**State of Alaska  
Department of Environmental Conservation  
Village Safe Water Program**

Re: Amendment 3  
ITB 26-VSW-UNK-011  
Unalakleet Water System Replacement Project  
ITB Due Date: October 9, 2025 @ 2:00 PM AST

**GEOTECHNICAL CONSIDERATIONS, WATER DISTRIBUTION SYSTEM, UNALAKLEET, ALASKA**

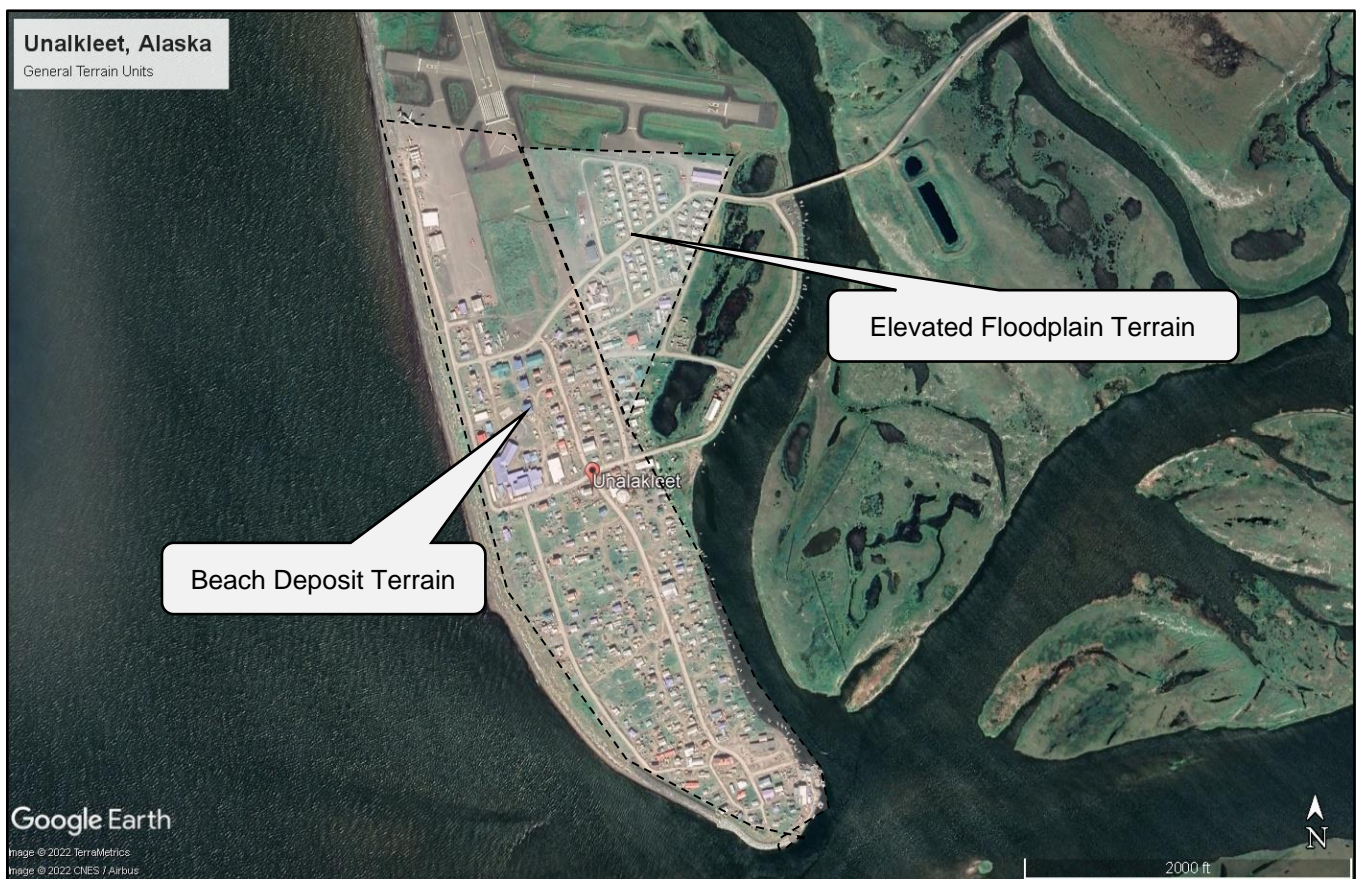
The planned water distribution replacement area is heavily developed with residential and commercial structures, numerous buried utilities within the roadway prisms, and extensive surface and near surface fill placement and reworked in-place soils. Based on our review of historic geotechnical data and imagery the undisturbed in-place soils may represent two key terrain units within the planned improvement area. The generally expected in-place soils, ground thermal states and approximate terrain boundaries within the planned water distribution replacement area are summarized below.

### Beach Terrain

Primarily sand and gravelly sand deposits possibly underlain at depth by mineral silty sand or sandy silt. Permafrost conditions are not anticipated in this terrain.

### Elevated Floodplain Terrain

Where undisturbed, a surface organic mat underlain by silty sand with variable gravel and possibly increased silt content. Random and discontinuous organic zones can be encountered. The potential for degraded permafrost exists in isolated areas, particularly in undisturbed areas with thicker surface or near surface organics.
